OREGON CITY

FILE NO.: HR 15-01

REQUEST: Approval of a new single family residence in the McLoughlin Conservation District.

FRONT ELEVATION

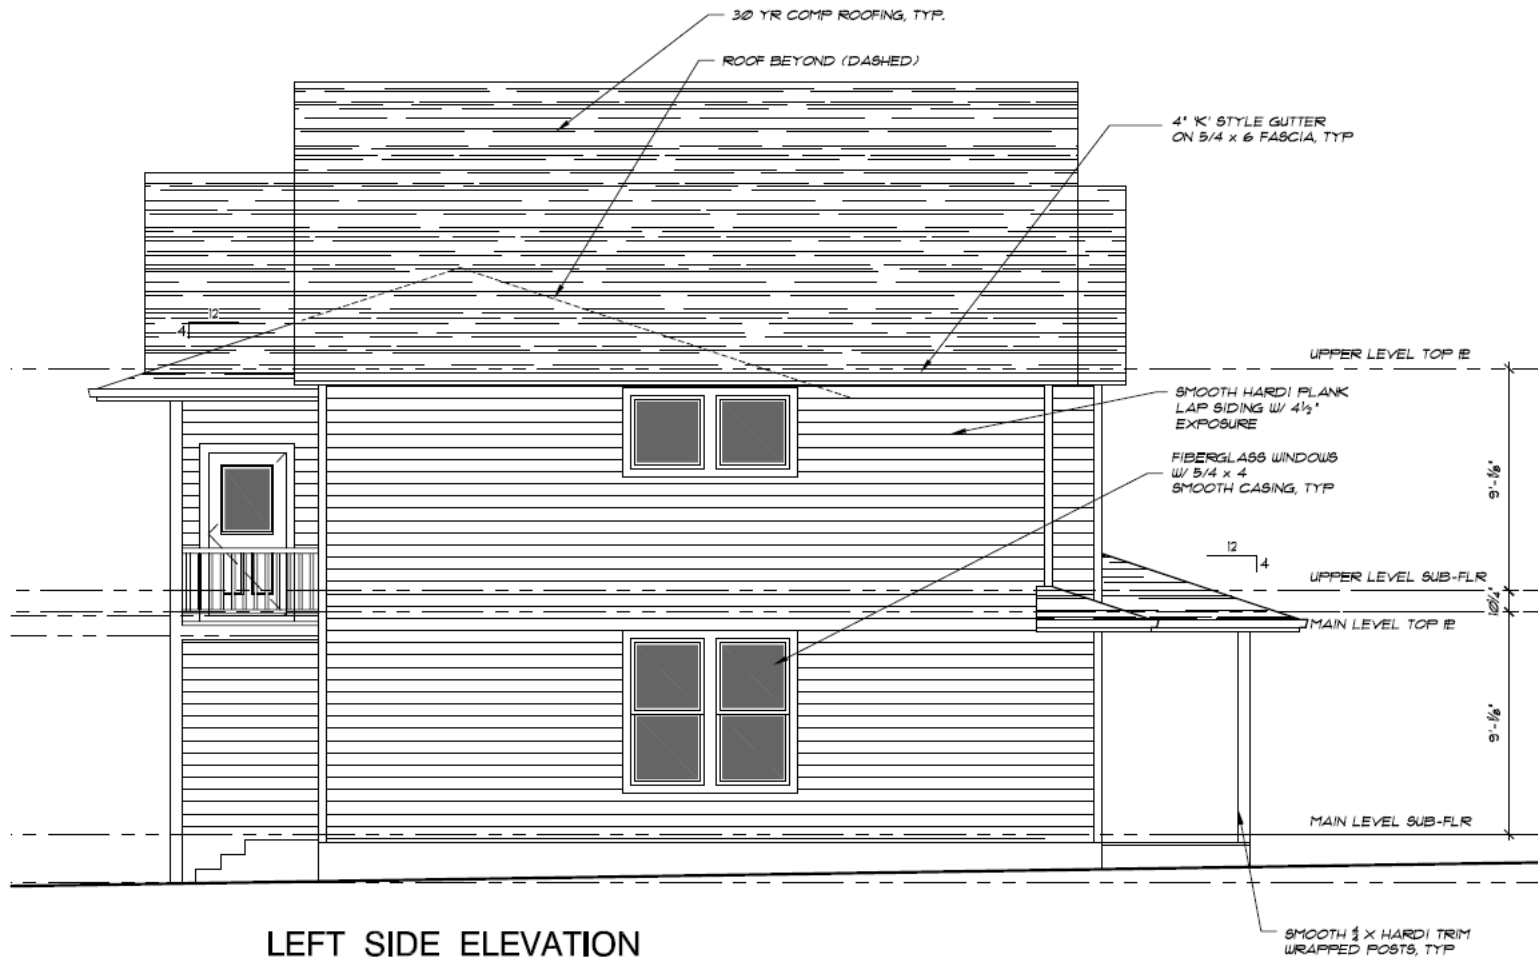
Finding: The building design is relatively clean and simple, as typical with the Vernacular style. The two building units – the primary residence and the detached garage/ADU – are basically rectangular in form with simple gable roofs. The primary residence has a secondary gable projecting out two feet beyond the adjacent wall to help break down the overall scale of the building as well as to define the entry. A hipped roof covered entry porch and small section of roof at the living area also help to add human scale to the façade.

The use of a shed, rather than hipped roof at the front garage façade and enlarged window openings on the rear façade, along with the inclusion of the verge board were design modifications based on the preliminary recommendations of the HRB. Staff finds that overall the application has submitted a Vernacular design that is compatible with the district by utilizing the topography, use of a semi detached garage to reduce the massing.

3. All railings, decking and stairs shall be finished to match the house body or trim.
4. The applicant shall utilize the following, unless an alternate has been approved by the Historic Review Board.

- a. Wood or fiberglass windows and doors. Fiberglass windows (Marvin Integrity or equivalent)
 - b. The window sash shall be the darkest color of the three color paint scheme.

- c. Wood or a minimum 4-4 1/2-inch reveal smooth composite siding
 - d. Simple vernacular styled lighting.
 - e. Simple paneled fiberglass or wood garage doors with or without windows.

LEFT SIDE ELEVATION

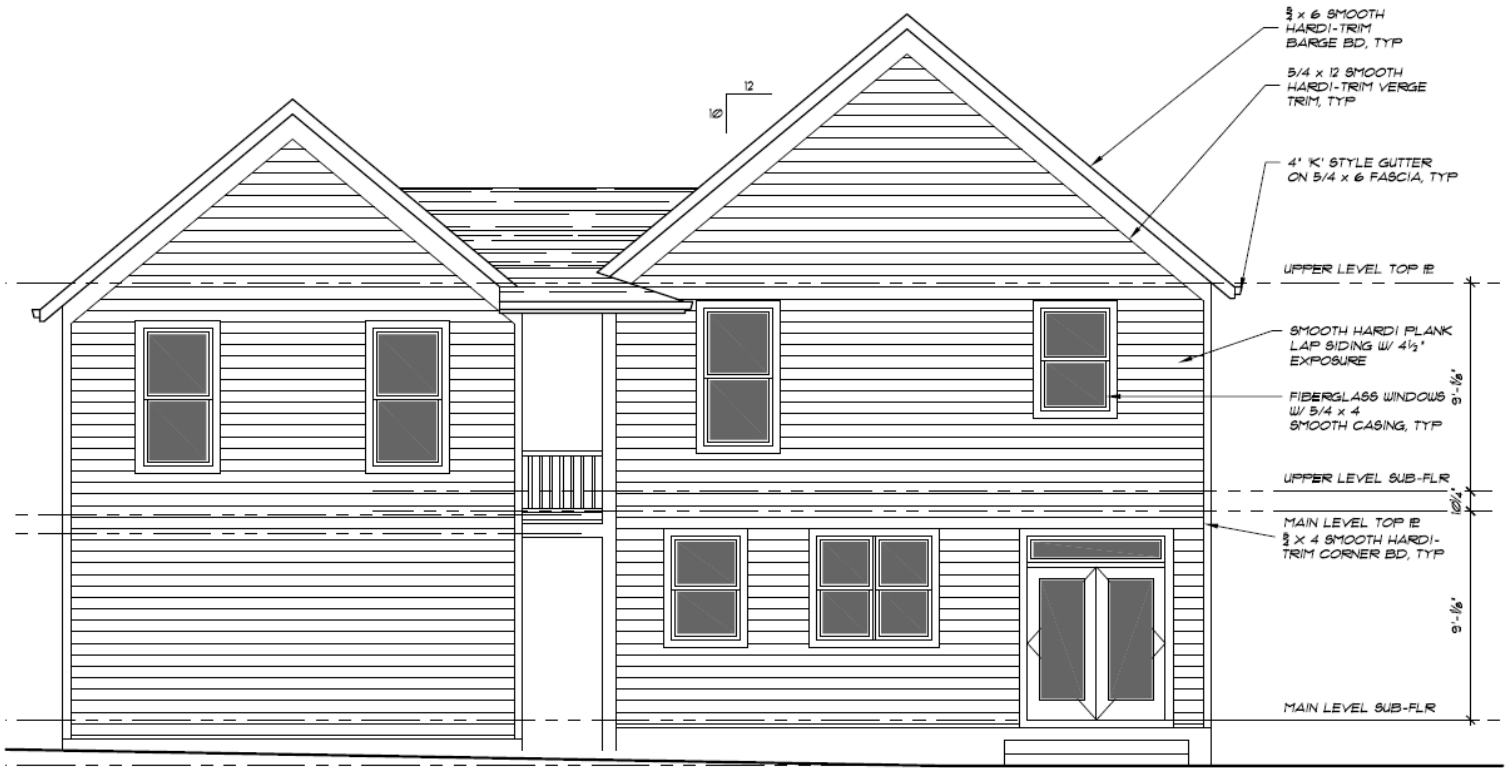
While the applicant has provided rear mock ups of the house to the proposed grade, staff is still concerned that the rear massing will be quite visible from 15th street below. Therefore, prior to obtaining a Certificate of Occupancy, the applicant shall submit an amended landscape plan that includes the following:

The garage/ADU building is set back 8' from the face of the primary residence. In addition to providing the necessary driveway apron, this setback identifies this portion of the residence as subsidiary to the primary residence. A simple shed roof extends across the entire front of the garage building, providing weather protection and giving the façade a more human proportion. An exterior composite wood stairway provides access to the upper level ADU and a connecting gable provides cover at this location between the two buildings.

- 3-6 additional minimum 1 ½ inch caliper trees that are a mix of native evergreen and deciduous with a minimum mature height of 35 feet planted within 30 feet of rear of the house to better buffer the new construction from downtown views and hide the massing of the building. Staff will review the final landscape plan at the time of C of O to determine the minimum number of trees require to meet this condition.
